Access Compliance Report

Public Rights-of-Way

(Curb Ramps)

Intersection ID: 51491	Main Street: N_TRYON_ST	Cross Street: INSTITUTE_CR	Location:	N
ADA ID: DDCFA1D62211	Ramp Type: Perp	Initial Pass/Fail: Fail	Overall Compliance: No	Severity Score: 10
Codes/Mitigation Info/Possible Solution		Field Measurements/Component Compliance

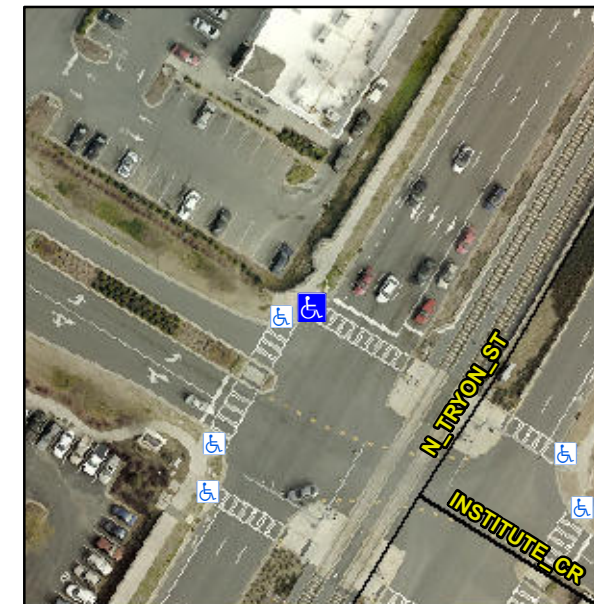
R304.5.1, R304.5.3

Compliance	Description	Data	Compliance	Description	Data
N/A	Ramp Length (in)	95.0	Yes	Ramp Slope (%)	6.8
No	Ramp Width (in)	47.0	No	Ramp XSlope (%)	3.5
N/A	Flare Type LT	N/A	N/A	Flare Type RT	N/A
N/A	Flare Slope LT (%)	N/A	N/A	Flare Slope RT (%)	N/A
N/A	Flare Traversable LT?	N/A	N/A	Flare Traversable RT?	N/A
N/A	Landing Length (in)	N/A	N/A	DWS Provided?	N/A
N/A	Landing Width (in)	N/A	N/A	DWS Contrast?	N/A
N/A	Landing Slope (%)	N/A	N/A	DWS Length (in)	N/A
N/A	Landing X Slope (%)	N/A	N/A	DWS Full Width?	N/A
N/A	Landing Curb? (Y/N)	N/A	N/A	DWS Offset (in)	N/A
N/A	Shared Landing?	N/A			
N/A	Gutter Ponding?	N/A	N/A	Gutter Slope (%)	N/A
N/A	Gutter Lip Ht (in)	2.0	N/A	Gutter X Slope (%)	N/A
N/A	Painted X Walk1?	No	N/A	Painted X Walk2?	N/A
	X Walk 1 Direction	To SE		X Walk 2 Direction	N/A
N/A	X Walk 1 Width (in)	N/A	N/A	X Walk 2 Width (in)	N/A
	X Walk 1 Slope (%)	1.4		X Walk 2 Slope (%)	N/A
	X Walk 1 X Slope (%)	3.3		X Walk 2 X Slope (%)	N/A

Remove & Replace Entire Ramp.
